MICE Spectrometer Solenoid 2B Issues

V.S. Kashikhin, July 19, 2010

The MICE Solenoid 2B review was requested by the FNAL Directorate because of several magnet system failures during tests at the vendor site. This report is based on findings during a visit to WANG NMR (See Appendix), discussions at LBNL, and MICE Notes [1] –[12]. The report is related to the possible failure scenarios and concentrates on the electromagnetic nature of these issues. In general there were two types of failures:

Fig. 3 Solenoid electrical circuit schemes: original (left), 2B test (right).

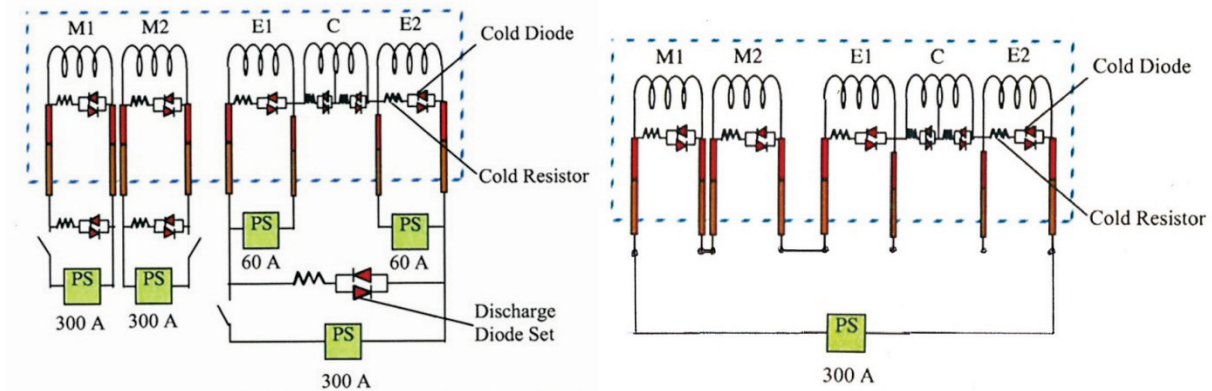
After fabrication the spectrometer solenoid was trained to achieve the specified operational current of 270 A. All 5 coils of the solenoid were connected in series and powered by the 300 A power supply (See Fig. 3). After the quench at 257 A, the M1 coil showed an open circuit. It is possible the following quench scenario occurred:

- Make a full quench analysis covering the test and operating scenarios. The model must include the real solenoid geometry and material properties;
- Modify the test procedure so all coils are not connected in series for training;
- Consider lower risk solenoid training. For example initially train coils M1 and M2. After that E1, E2, CC with coils M1-M2 powered from a separate power supply at the peak current achieved during training for M1-M2. In this case the M1-M2 circuit will have a small current-field margin and will be quenched almost simultaneously with E1-CC-E2.

Fig. 7. Upper and HTS leads configuration.

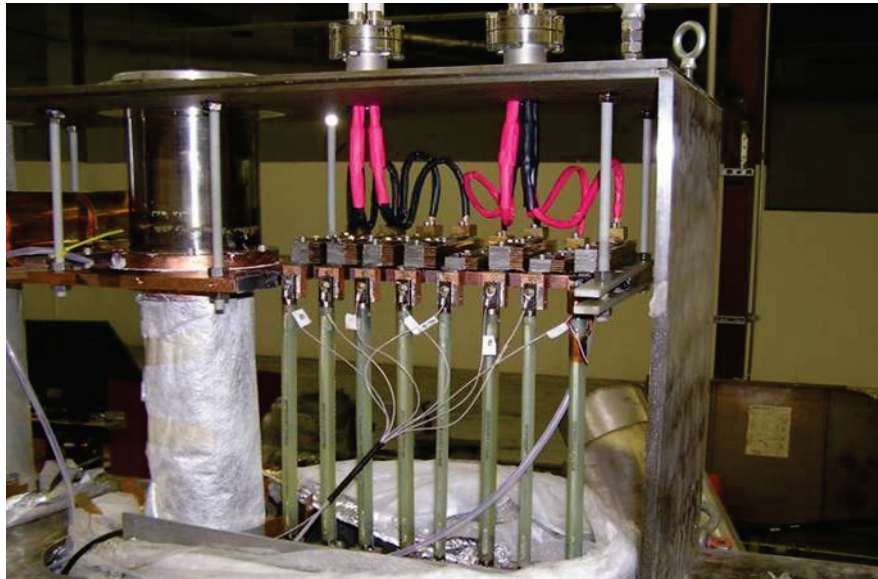
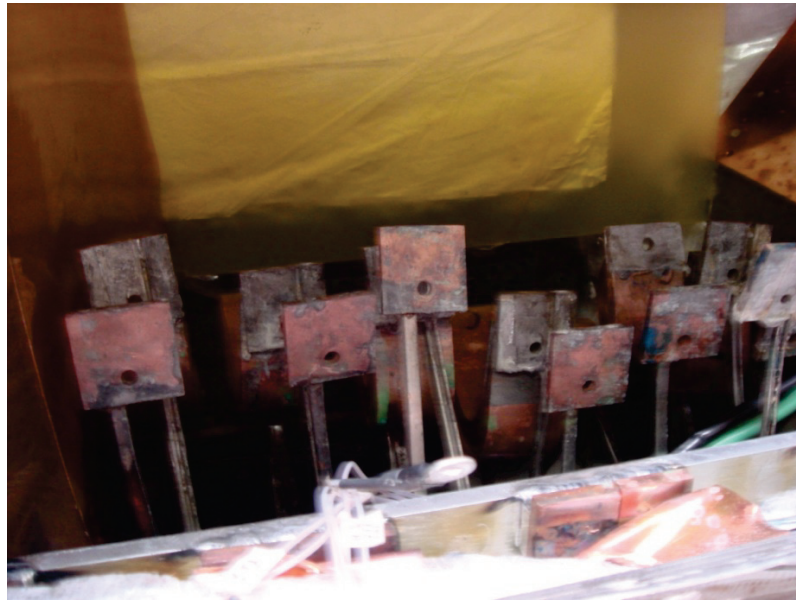
The steady state magnetic field analysis showed that the calculated peak fields are in agreement with the MICE documentation. Nevertheless, it should be noted that manner in which the current leads were installed does not necessarily result in the position of the leads being fully known after cooldown (See. Fig. 7, Fig. 8).

In addition the cold mass axis position was not absolutely fixed during assembly, there is some chance that it could deviate from the outer vacuum vessel axis. Between the two effects, there is some chance the HTS current leads could catch substantial perpendicular field component which will reduce the lead performance (See Fig. 9). This field also could generate circulating currents in the HTS which will additionally heat up these leads during ramping. A more complete analysis and assembly plan should be completed to better understand the position of the leads. If warranted, the addition of a ferromagnetic shield around these current leads will eliminate this effect.

Fig. 11 Cold feedthrough view.

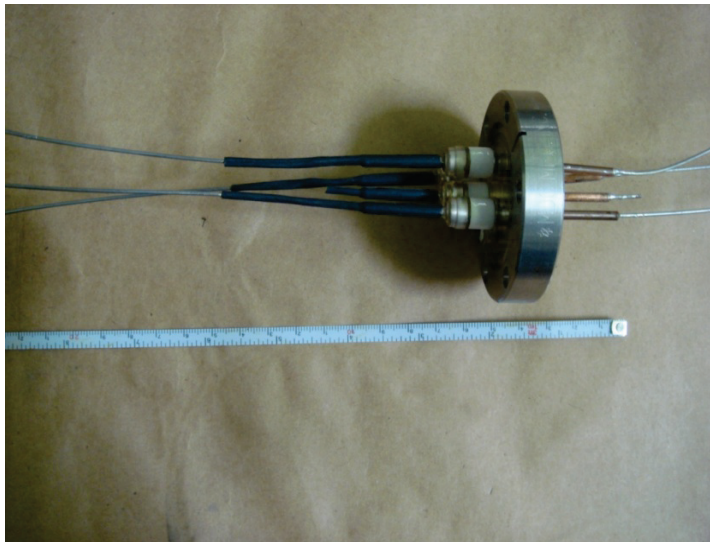
Our calculation showed that the field in the cold feedthrough area is less than 0.1 T (See Fig. 10). In this area there should not be any noticeable Lorentz forces and the field influence on the superconductor performance, even without further stabilization, should not be significant (See Fig. 11).

The superconducting wire on right side of the feedthrough was not additionally stabilized because of limited access to this area during assembly. This area may overheat during a quench.

- If the failure is between the shunt resistor and the feedthrough, Improve the cold feedthrough area and other areas with a single superconductor strand by adding extra copper stabilization;
- If the failure is between the shunt resistor and the coil, the quench protection system should be completely reanalyzed and the modified such that the coils are adequately protected. This could include the introduction of an active quench protection system, or re-optimization of the shunt resistors, for example. Further stabilization of the superconductor strand near the feed through is probably a safe modification in this case as well.
-

Fig. 15 Coil temperature rise during quench because of mandrel heating.

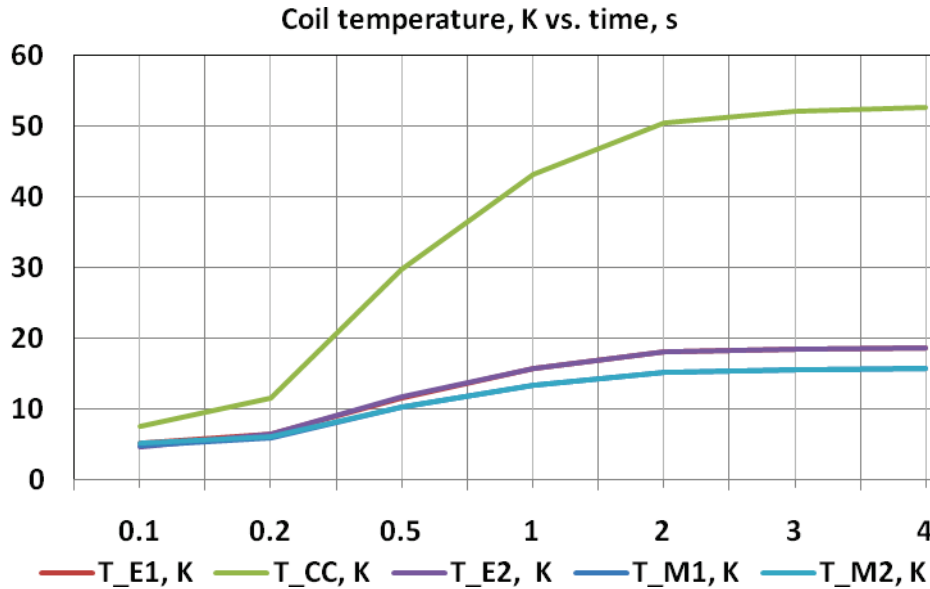
Because the induced current in the mandrel is concentrated under the quenched central coil CC, the central coil is heated to 50 K after 2 s. This is in an addition to any resistive coil heating. The time of the other coil quenches is the sum of the Al mandrel heating time and the heat transfer from mandrel to the coil. Coils E1 and E2 will be quenched after ~ 1.5 s. Coils M1 and

M2 will see “quench back” effect after ~ 2.2 s. If the real thickness of ground insulation is larger than 1 mm, this delay will be even larger due to the additional thermal resistance of the insulation layer. Fig. 15 shows the coil temperatures at different times. It should be noted that power losses in the mandrel during magnet charging with rate of 0.06 A/s is only 0.065 W and does not produce substantial additional heat load. In [5] these losses were estimated at 0.036 W and the AC superconductor hysteresis losses at 1.01 W during the solenoid charge time 4620 s.
